SUMNER-BONNEY LAKE SCHOOL DISTRICT SUMNER HIGH SCHOOL ADDITION - PHASE 2 VALUE ENGINEERING REPORT SEPTEMBER 12, 2025

Revised 10/13/2025 with updated Implementation Data

This value engineering (VE) report is presented to Sumner-Bonney Lake School District and the design team to support decision making at the design development phase for the Sumner High School Addition - Phase 2 project.

Value Proposal Concept

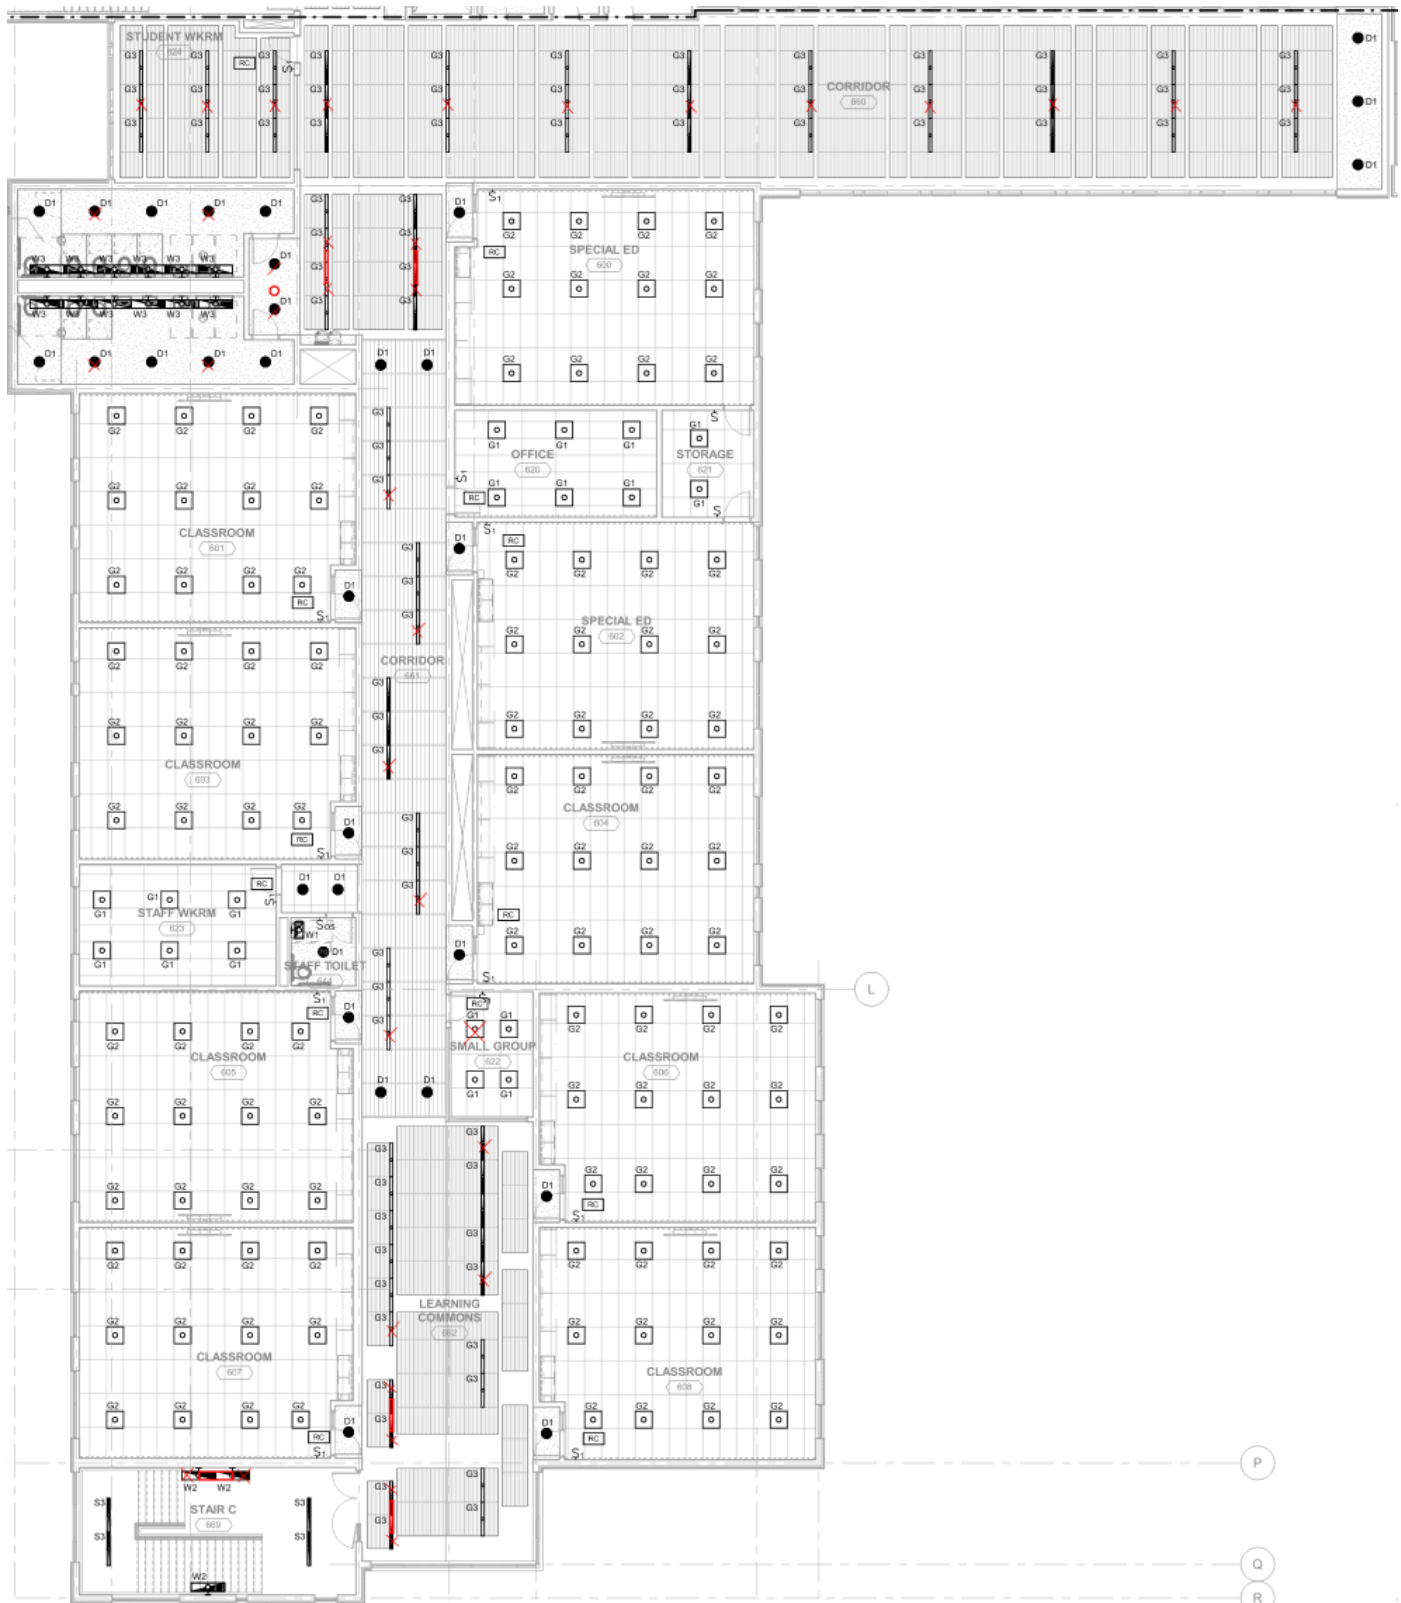
PROPOSAL	E2
COMPONENT: Lighting Density	AUTHOR	MW
BASELINE CONCEPT: The current design provides 10% lower power density than code. Light fixture layout provides design light levels and maintains even light level uniformity.		
VALUE PROPOSAL SYNOPSIS: Provide 20% lower power density than code. Light fixture layout provides slightly lower light levels and maintains even or slightly reduced light level uniformity.		
SCHEDULE SAVINGS: Improved		
QUALITATIVE BENEFITS:		
RELIABILITY	M&O	FUNCTIONALITY
Improved	Improved	Maintained
FUNCTIONS:		
Enhance Vision	Illuminate Surfaces	Illuminate Egress
ADVANTAGES: <ul style="list-style-type: none"> • Reduced Material Costs • Improves Schedule • Reduced Labor • Improved Maintenance • Life Cycle Cost Savings 		DISADVANTAGES: <ul style="list-style-type: none"> • Reduced Light Level • Reduced Lighting Uniformity • Added Supplemental Lighting.

The lighting design in classrooms will be unchanged. The proposed lighting design in other spaces and corridors will result in an additional 10% reduction in lighting power density. The effect on lighting will be slightly lower light levels and slightly less lighting uniformity.

E2	Lighting Density	151,000		X		0	Hargis Response: Reducing fixture quantity does not inherently mean 20% LPD reduction is achievable as the fixtures lumens and wattages are being prescriptively selected through photometric calculation. The suggested deletions particularly in the stairwells will make it nominal from a lighting level standpoint and make the PH2 stairs different than PH1 stairs. We do not suggest accepting this item.
R1	Use pavers ILO concrete in courtyards (assume 50%)	(280,460)		X		0	Fora Response: High quality pavers would add significant cost, however paving interest will be improved through creative placement of joints and use of surface retarder at select locations.
R2	Raise concrete crosswalks to slow traffic and improve safety	(17,100)		X		0	JCE Response: REJECT - Discussed with School District and architect, we will add speed bumps in-lieu of raised concrete to slow incoming traffic. Fora Response: Raised crosswalk would conflict with grading/drainage of parking lot, District has expressed interest in speed bumps with more limited cost impact - Fora will work with civil to locate these while minimizing impact to grading/drainging of parking lot.
